STATE OF NORTH CAROLINA
DEPARTMENT OF TRANSPORTATION

Subject: DCM Consistency for the proposed US 70 Havelock Bypass in Craven County. TIP No. R-1015. WBS 34360.1.2.

The North Carolina Department of Transportation (NCDOT) submitted additional information on Havelock Bypass to you on March 13, 2020 for review in regards to the Division of Coastal Management's CAMA Consistency Determination for the project. This package included supplemental information and revised permit drawings. Based on further coordination with the NC Division of Water Resources, further revisions need to be made to this request. This letter is a revised version of the March 13, 2020 request, showing additional and modified information highlighted in red.

PERMIT DRAWING
SHEET 142 OF 165

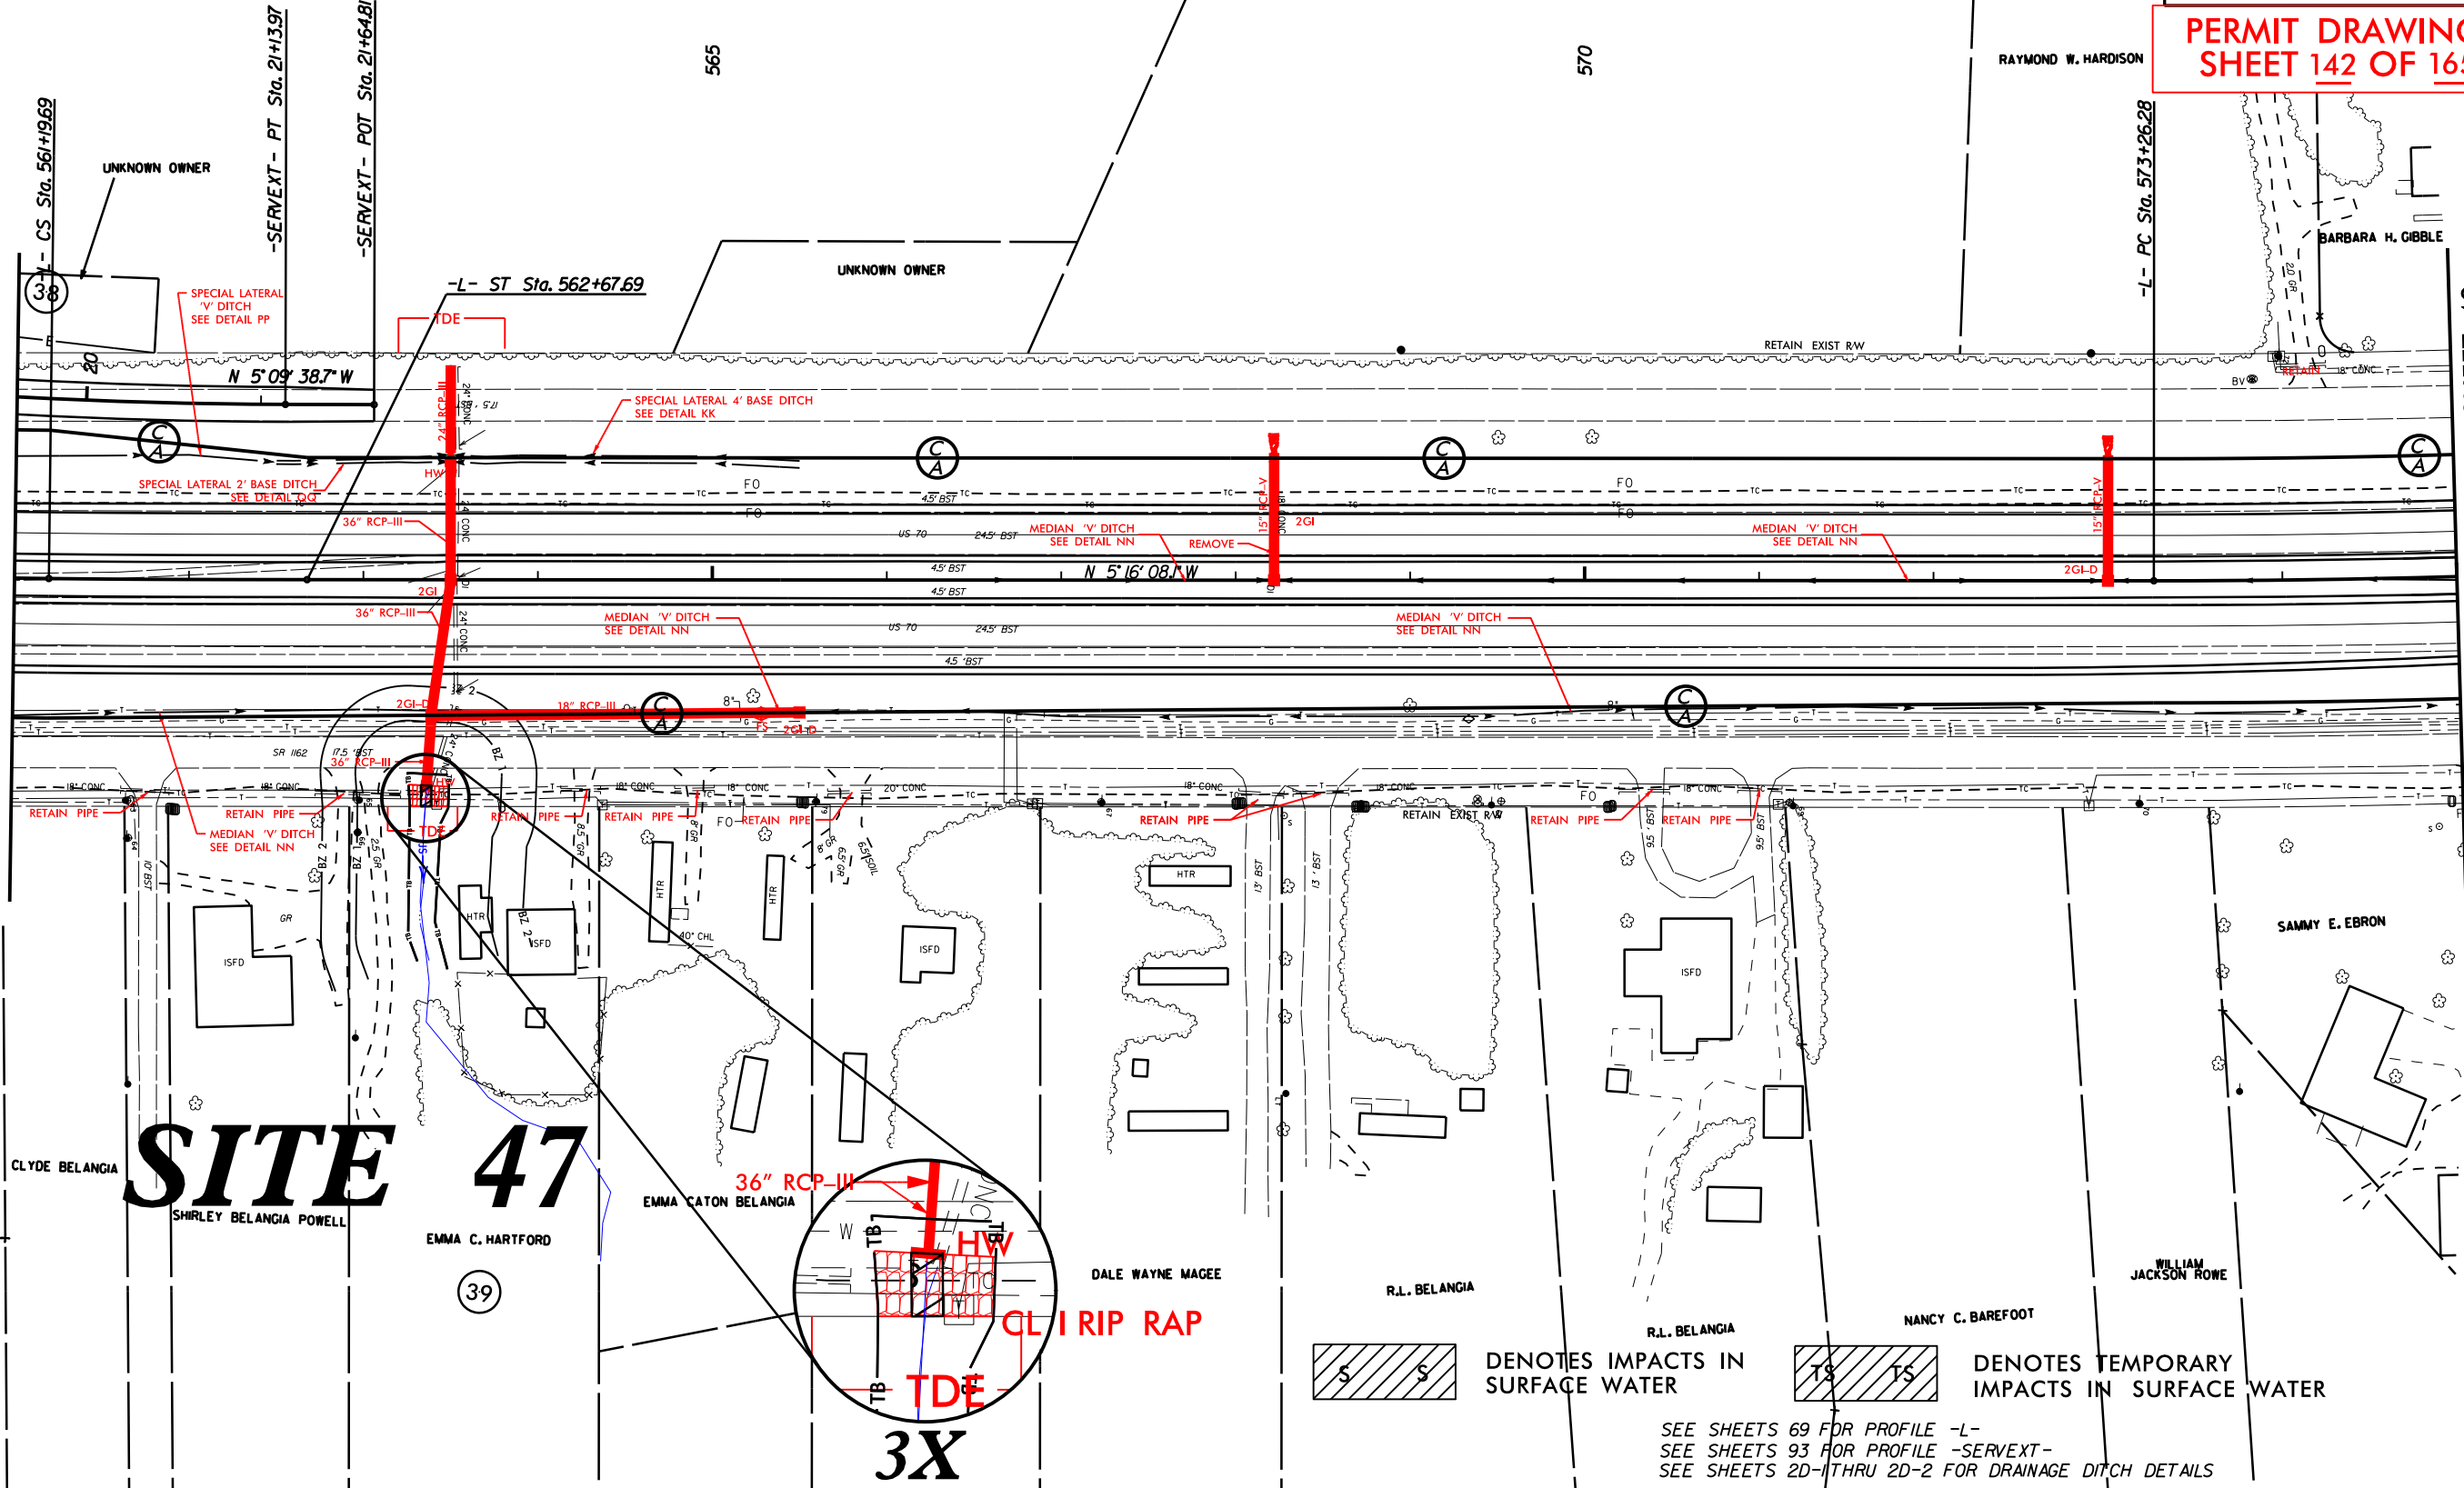
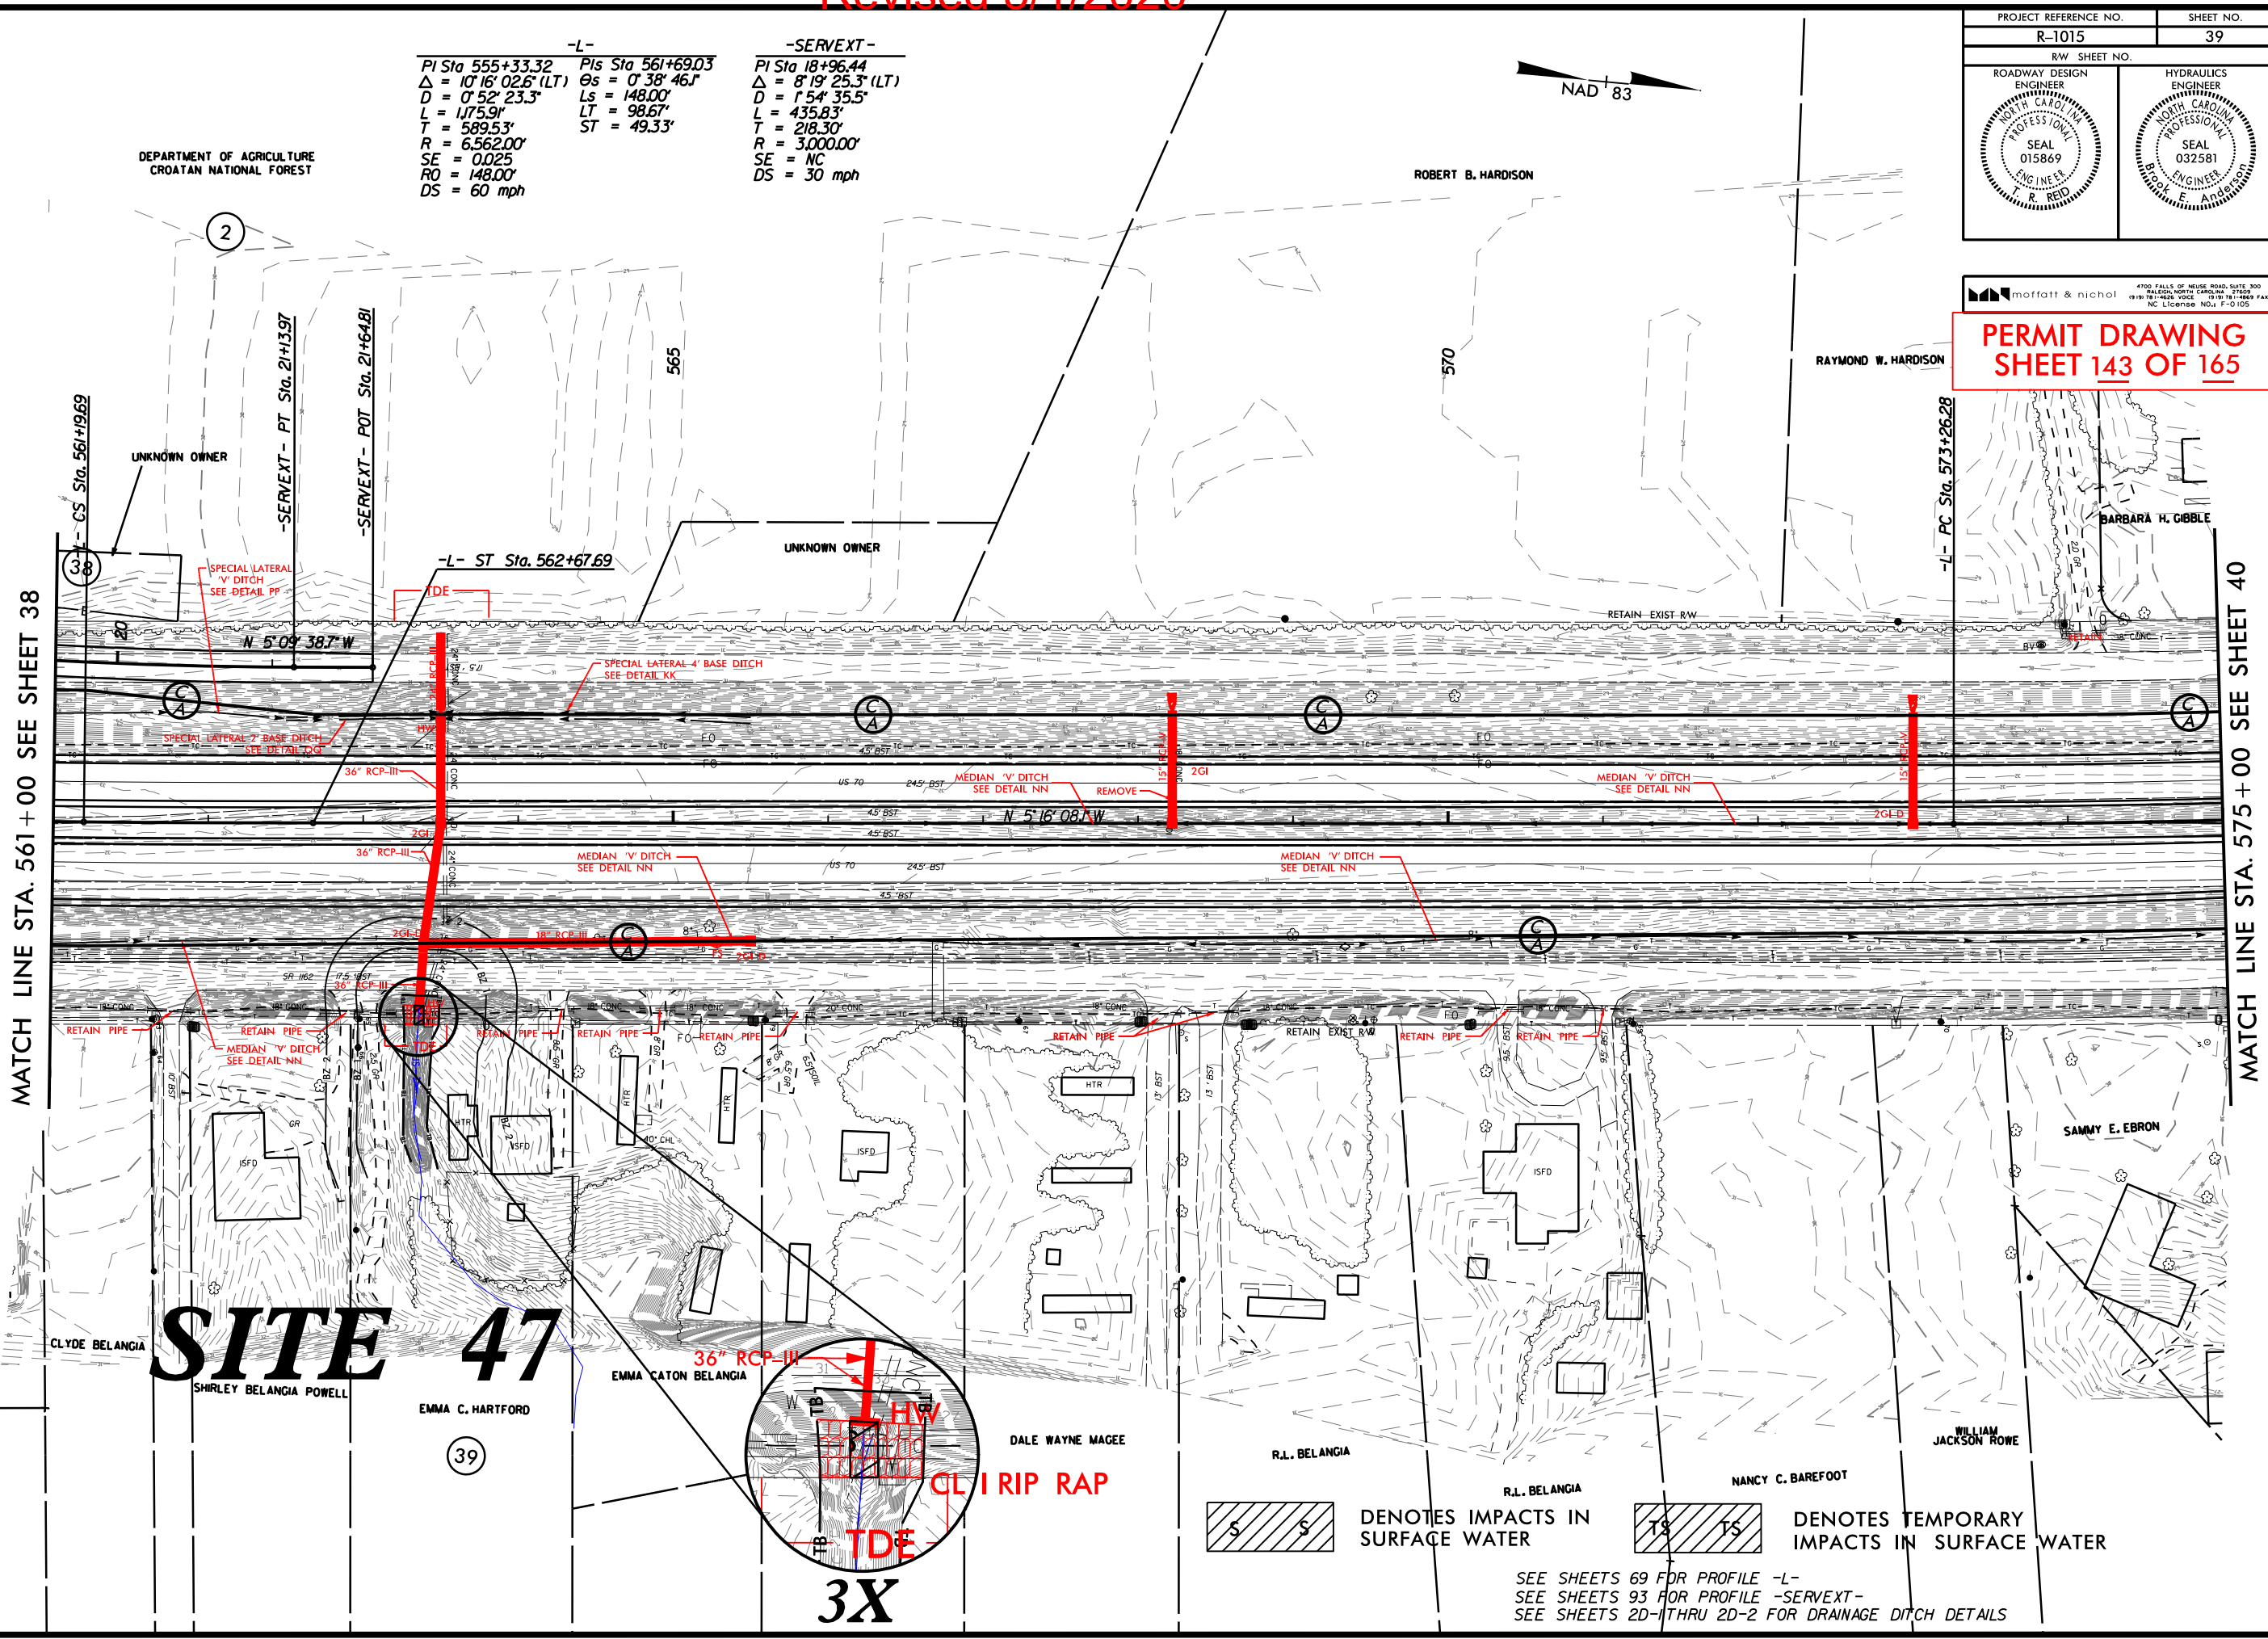
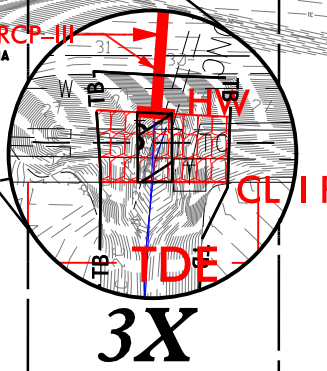
- Fill in Wetlands (new = 2.2231 acre, old 2.2289 acre)
 - Excavation in Wetlands (new = 0.068 acre, old 0.072 acre)
- Site 47, (permit sheets 142 & 143) pipe shortened to eliminate easement on property, HW added. “Temporary Impacts in Surface Water” reduced by 0.01 ac. “Existing Channel Impacts Temp.” reduced by 10’.
